**Draft Proposal for the Lake only in
Cherry Orchard Country Park**

**Response from
The Friends of Cherry Orchard Park
July 2015**

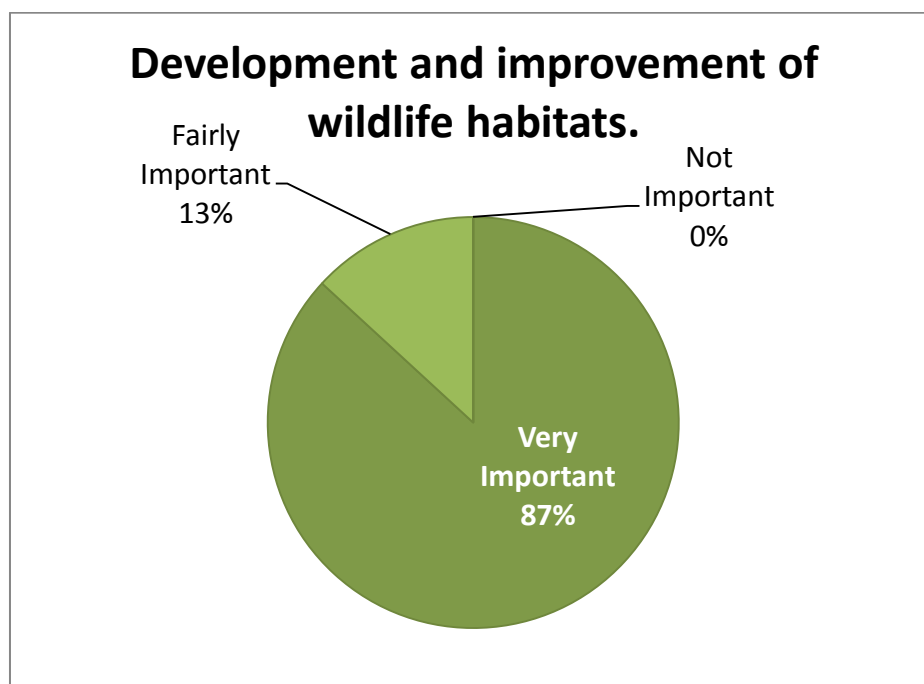
This is welcomed. However, are the planners aware that a natural wet area forms for several months each year closer to the south east corner of the lake? This area is not formed by the lake overflowing onto the meadow, rather as the wet area enlarges it overflows eventually into the lake.

We believe this should be taken into consideration when planning a possible path/route along the southern boundary of the lake.
